PLAN OF PROPOSED IMPROVEMENT

5109 BARTON ROAD

CITY PROJECT NO. 14773
CONTRACT NO. 9223

14773
 L-1

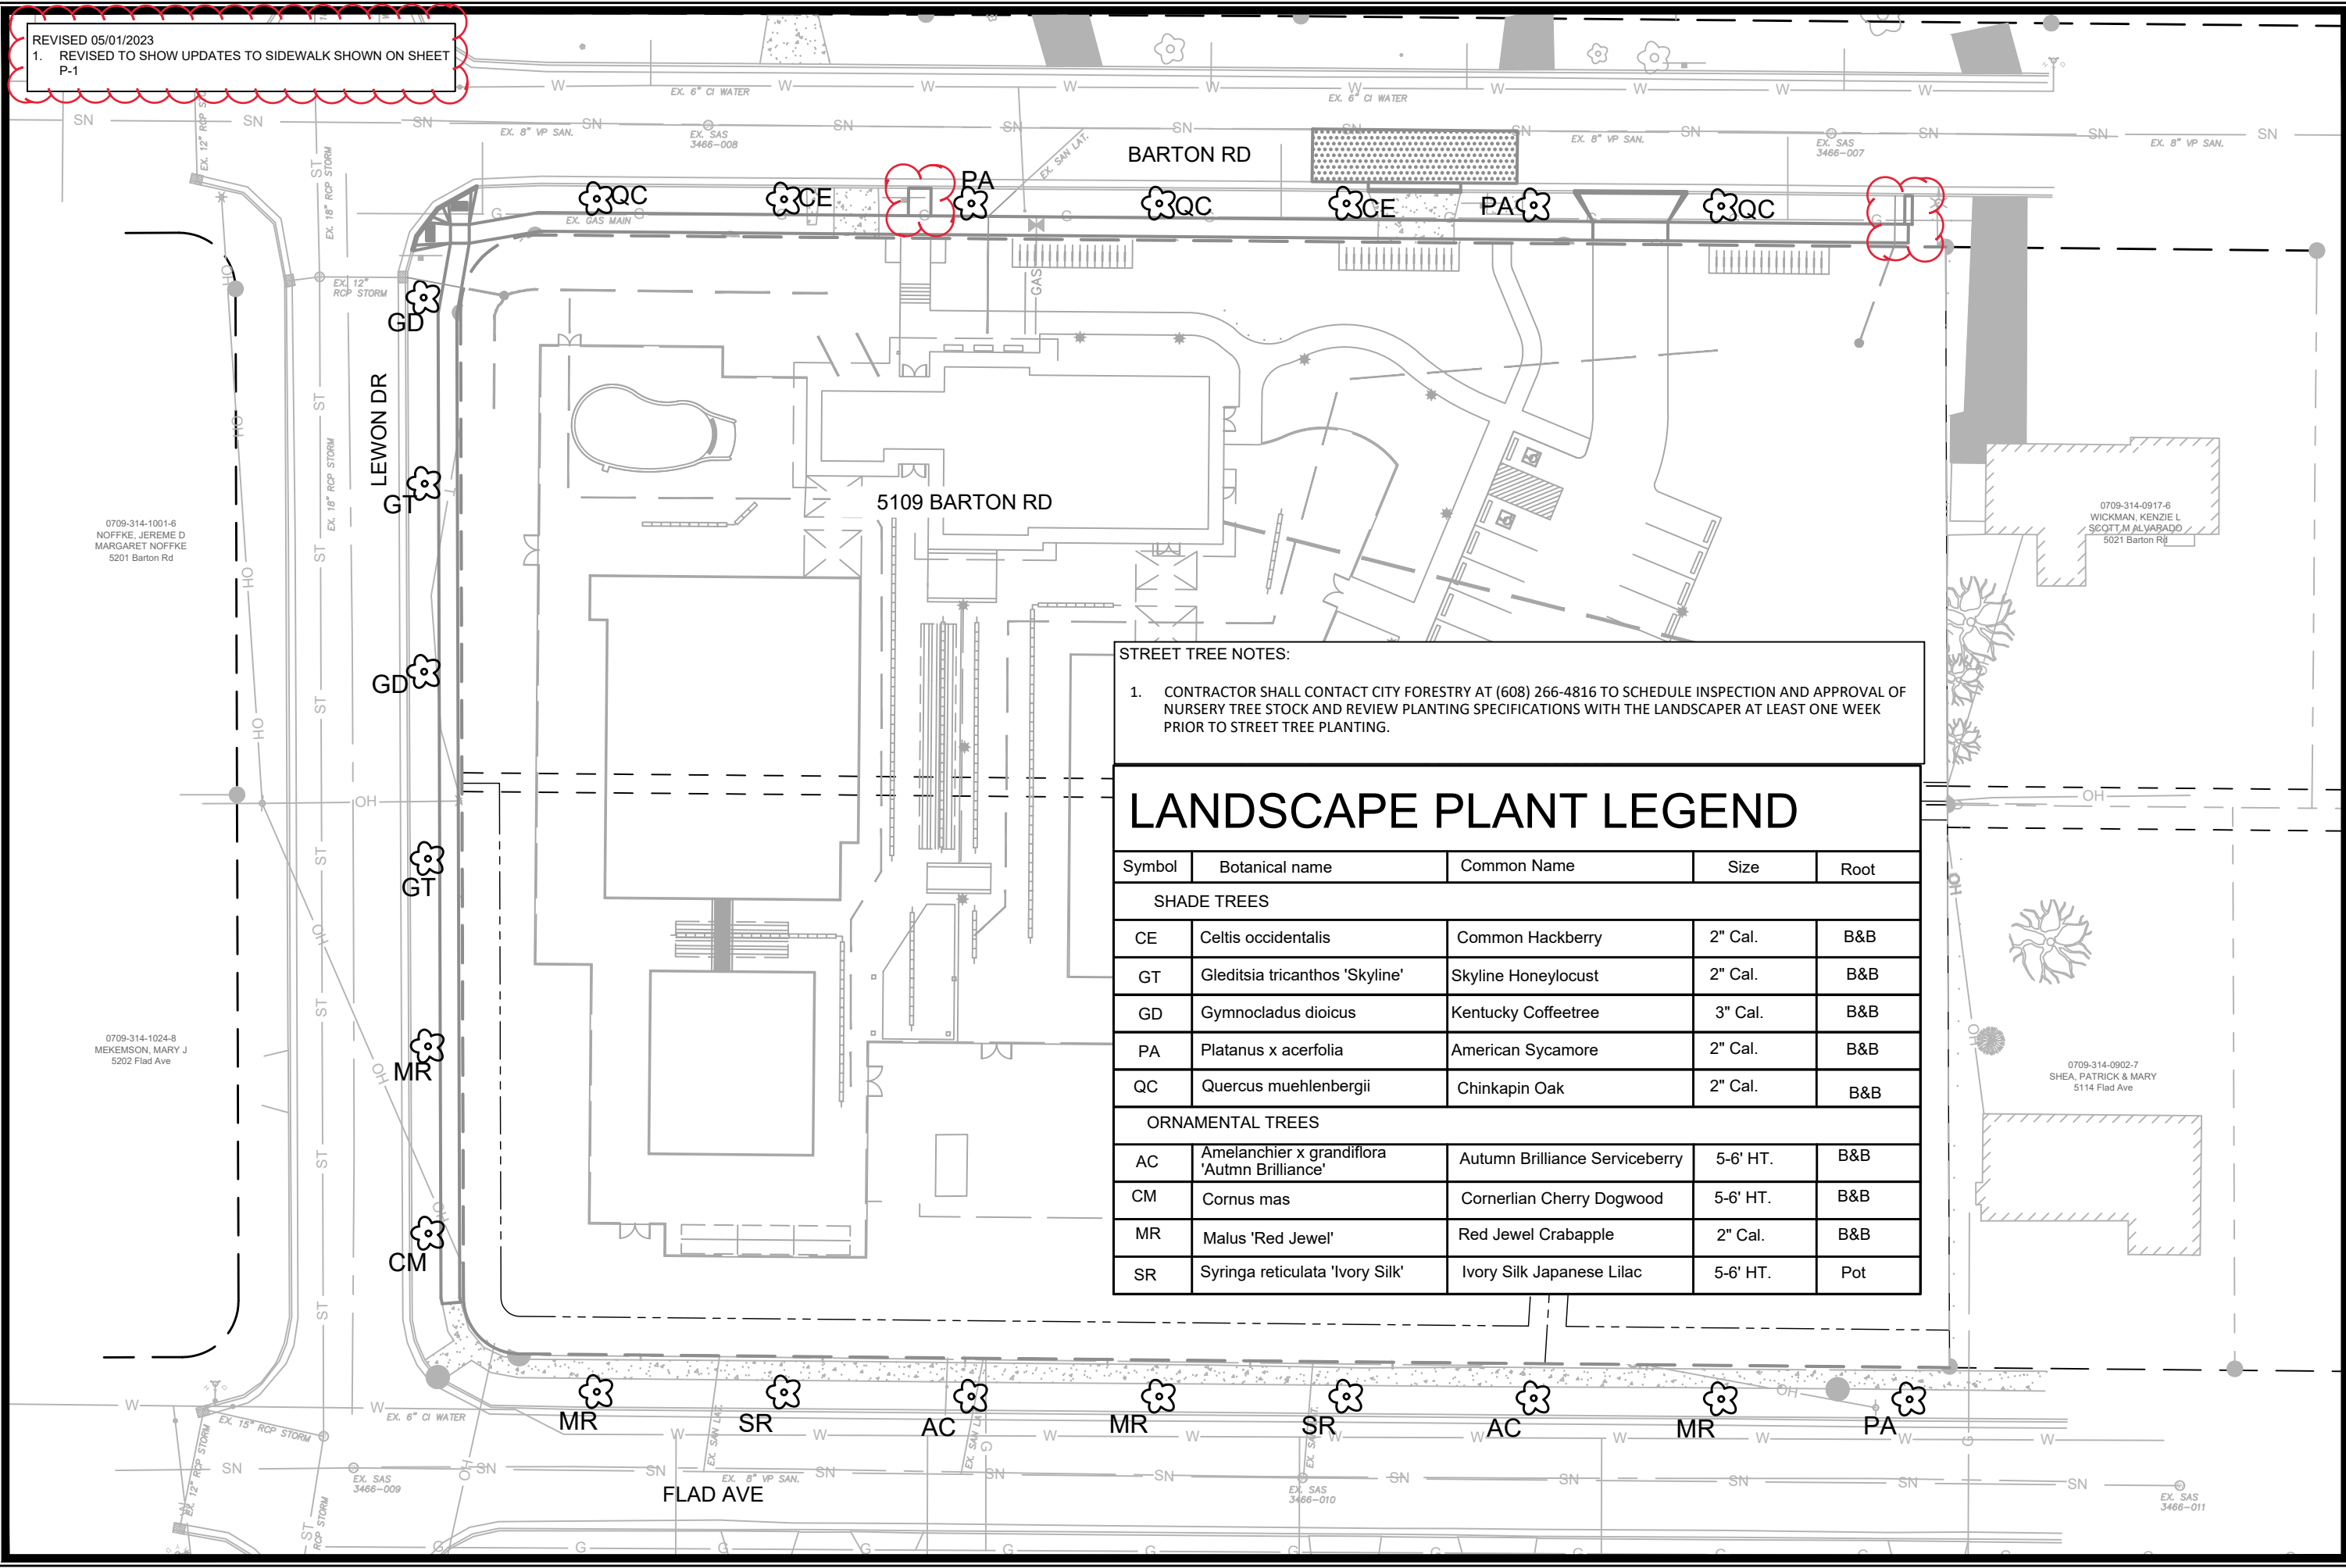
REVISED 05/01/2023
 1. REVISED TO SHOW UPDATES TO SIDEWALK SHOWN ON SHEET P-1

14773				
P-1

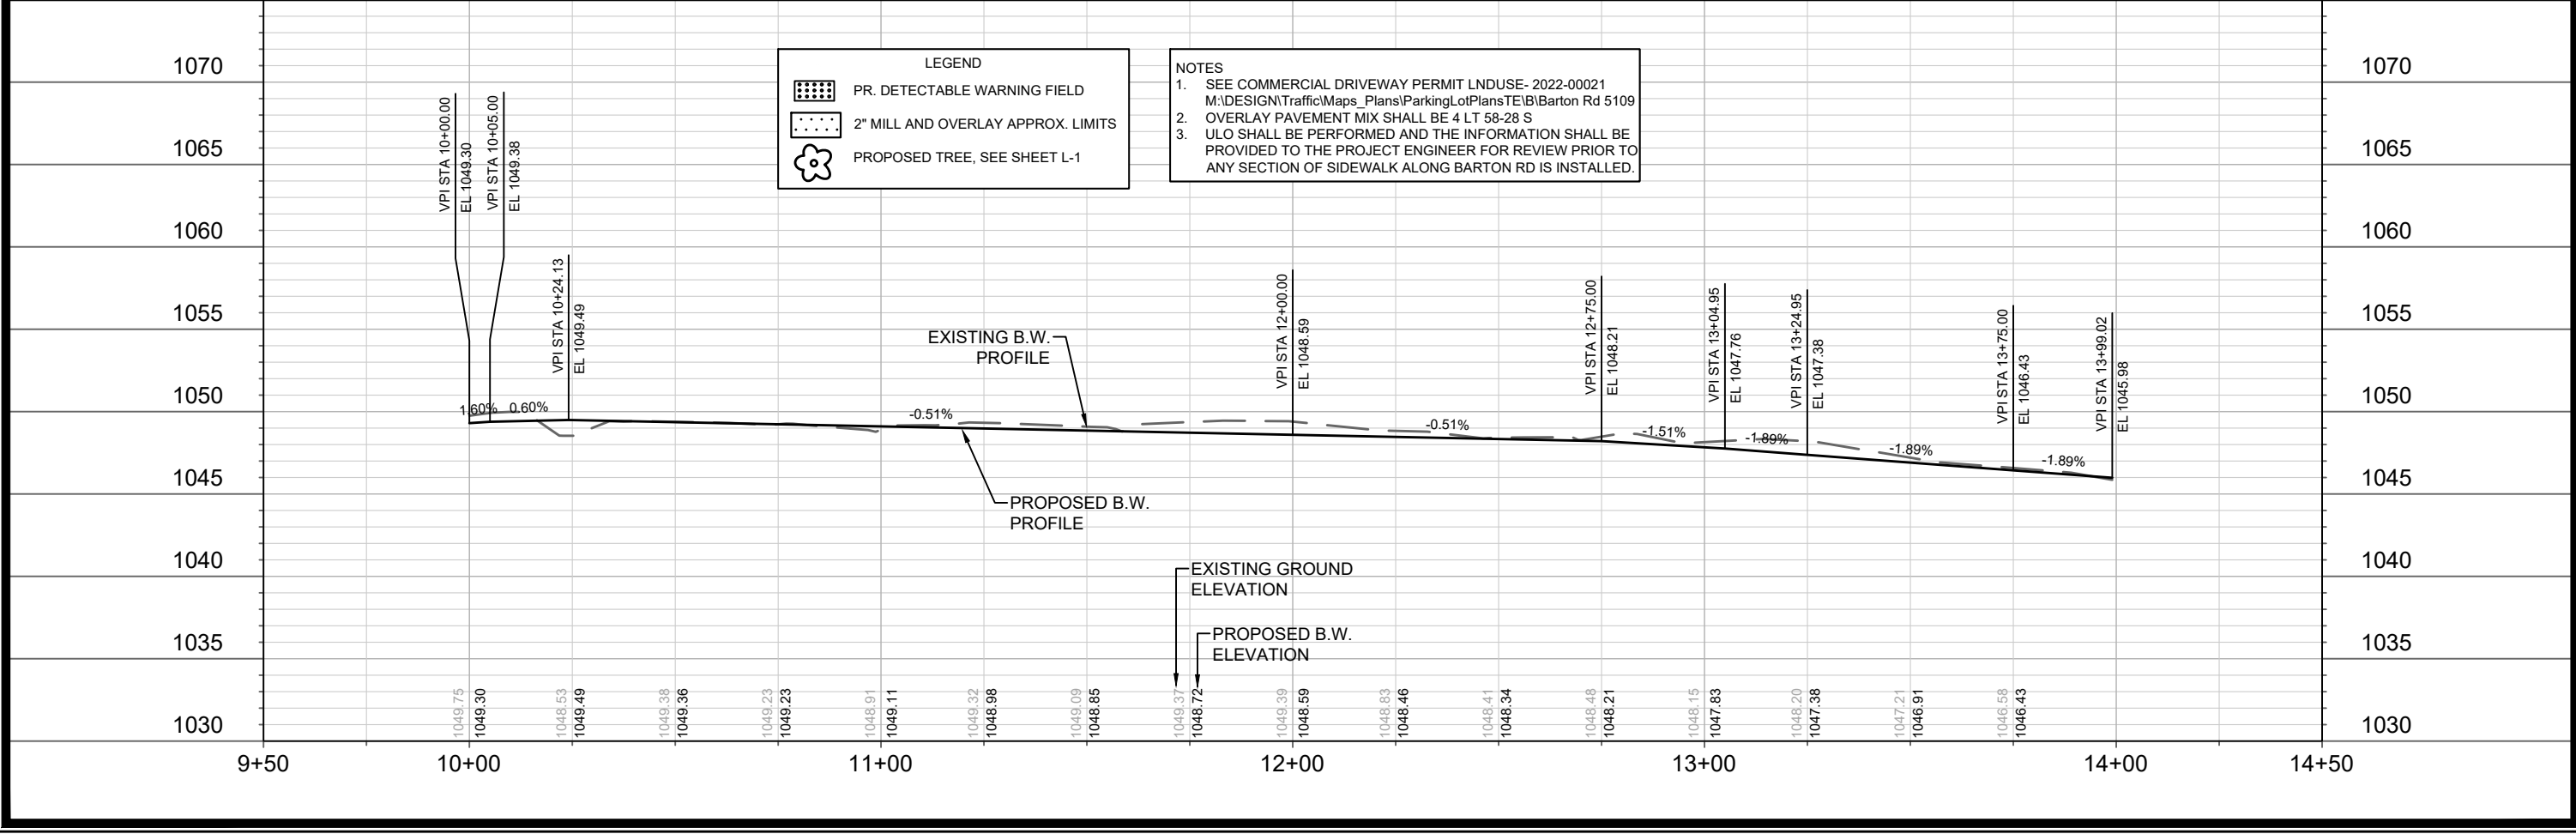
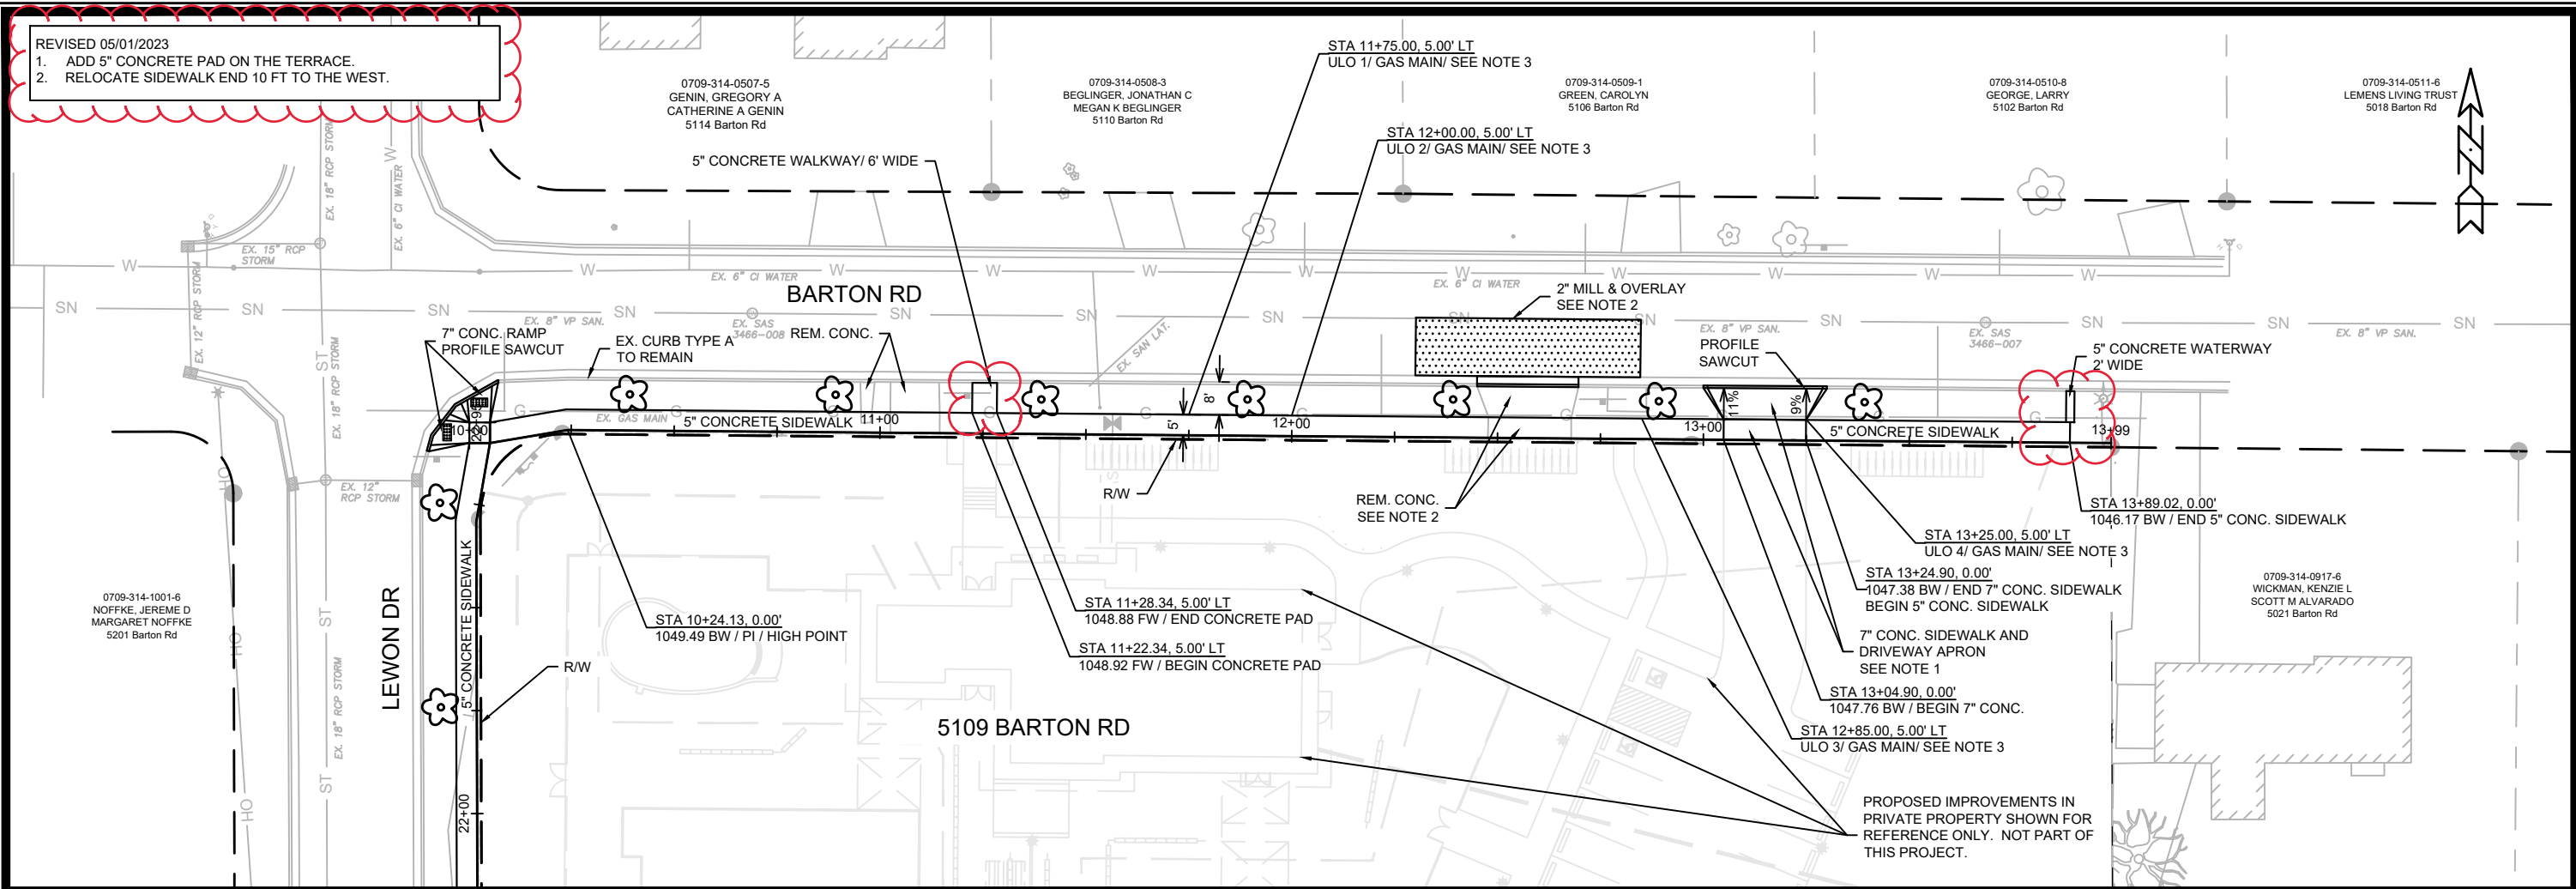
REVISED 05/01/2023
 1. ADD 5" CONCRETE PAD ON THE TERRACE.
 2. RELOCATE SIDEWALK END 10 FT TO THE WEST.

14773	14773	9223	14773
PLAN & PROFILE - BARTON ROAD	MADISON, WI	CONTRACT NO.:	P-2
5109 BARTON ROAD			
14773			
P-2

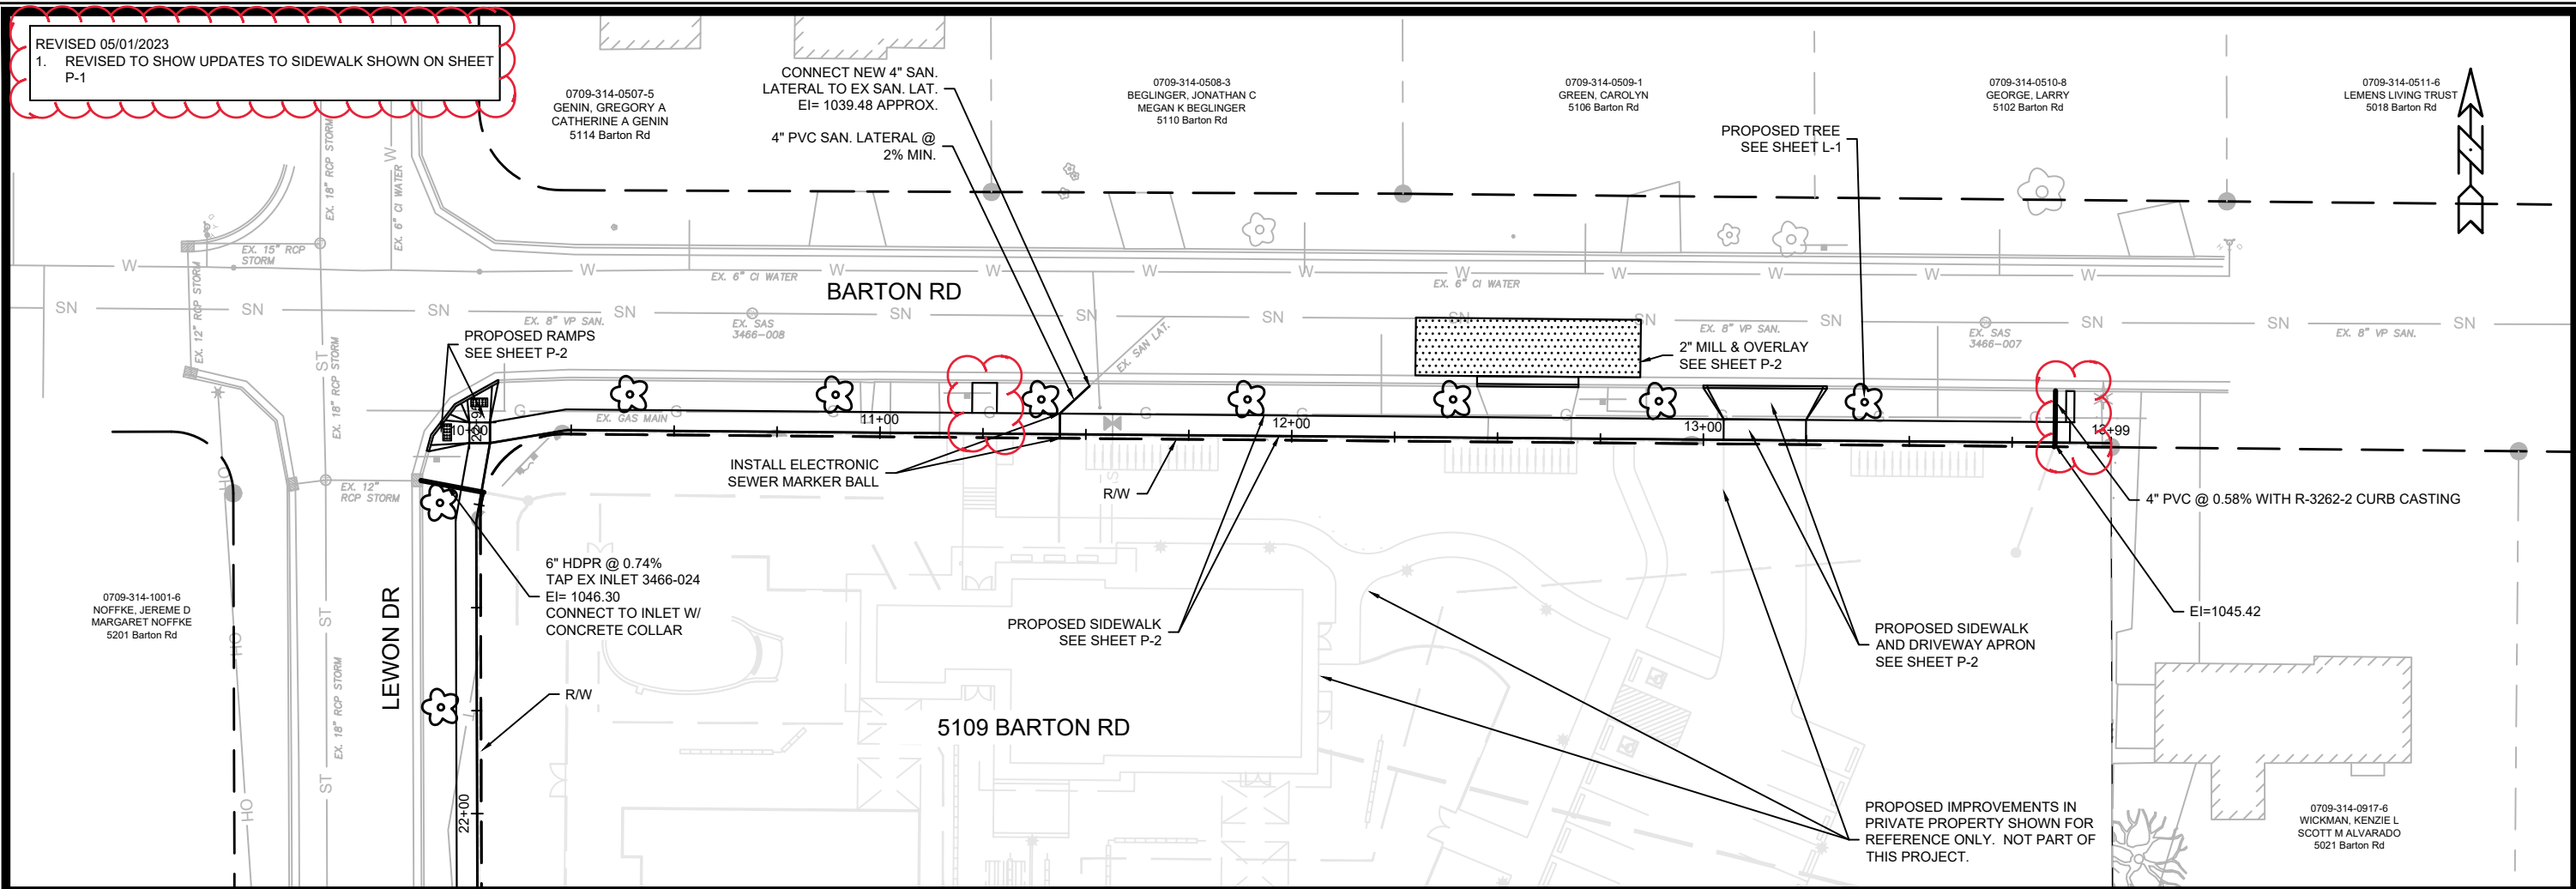
REVISED 05/01/2023
 1. REVISED TO SHOW UPDATES TO SIDEWALK SHOWN ON SHEET P-1
